**Subject: Proposed Revision of TDEC NRS No. 09.009 (ref. USACE Permit No. 200502425), Discharge of Fill Material into Wetlands and Streams Associated with the Expansion of the Bledsoe County Correctional Facility, Pikeville, Bledsoe County, Tennessee**

**Proposed Upland Buffer Revision  
Bledsoe County Correctional Complex  
Stream and Wetland Mitigation Site  
Pikeville, Tennessee**

**Figure 1, Revised Planting Plan**

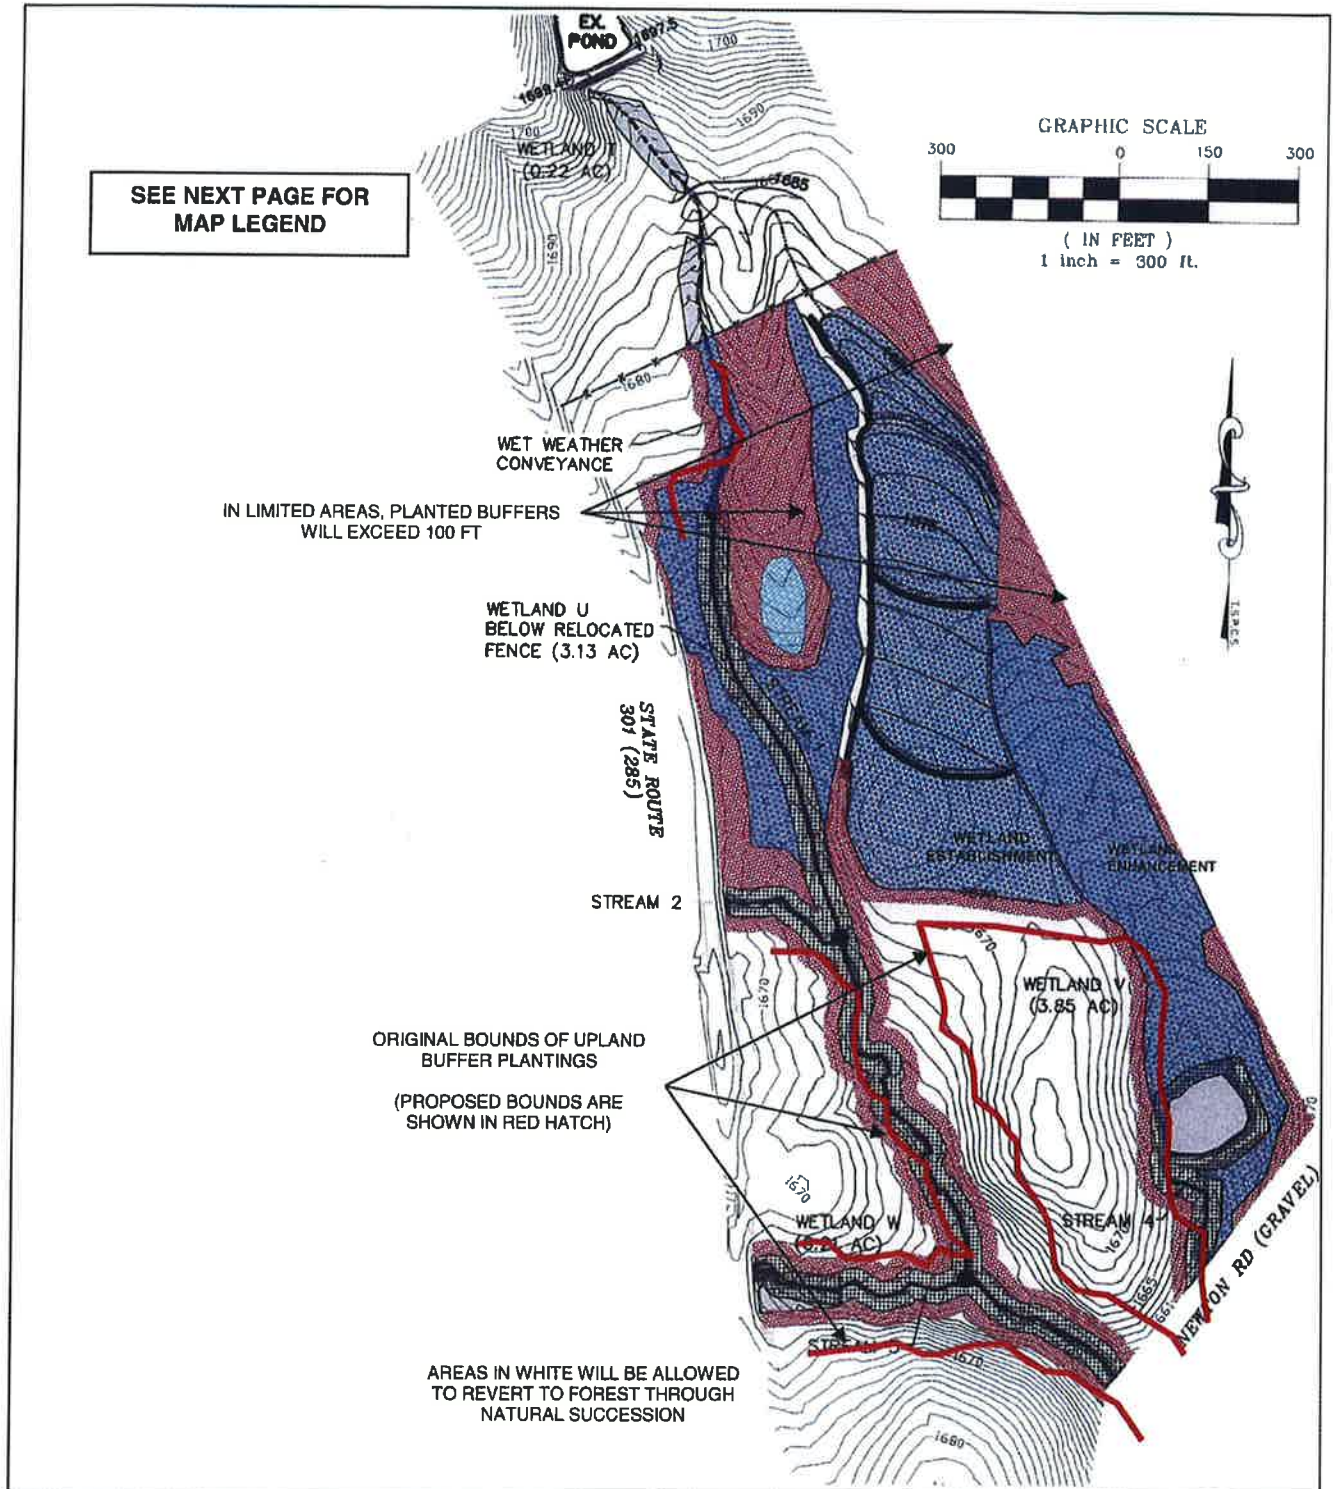
Streams 1, 2, 3, and 4: We are proposing to lessen the widths of upland oak buffer zones from 50 ft to 25 ft along both flanks of Stream 1 below its confluence with Stream 2, and along both flanks of Stream 3. We are also proposing the same actions along the south flank of Stream 2 and the west flank of Stream 4 (see Figure 1).

Being that total buffer width on these small, seasonal waterways will still exceed 50 ft on either side (25 ft riparian plantings and minimum 25 ft upland oak planting), we believe this modification falls within the guidelines set forth by TDEC.<sup>1</sup> Additionally, it is important to note that upland areas lying immediately adjacent to the planted buffers are part of the mitigation package and will never be developed. They will be allowed to become forested through natural successional processes and themselves will offer future protection to the site's aquatic resources.

Wetland Establishment and Enhancement Area: Oak buffers along the southern boundary of the wetland creation area and western half of one of the site's wetland enhancement areas will also be reduced from 50 to 25 ft (see Figure 1).

Since we are unaware of any promulgated requirements for planted upland zones adjacent to wetland mitigation areas, the main goals associated with establishing vegetated uplands are to provide erosion resistant buffers and habitat diversity for indigenous plants and animals. We believe that reducing the amount of planted oaks will not have a negative effect on either of these goals. This is especially true since, as was stated above; adjoining uplands will be legally protected in perpetuity and will become forested through natural succession. Undoubtedly, a portion of the future species mix will contain native oaks. It should also be pointed out that a number of segments in the northern part of the mitigation area will contain oak buffers that will exceed 100 ft wide. The most significant of these surrounds the (state-endangered) granite gooseberry transplant site.
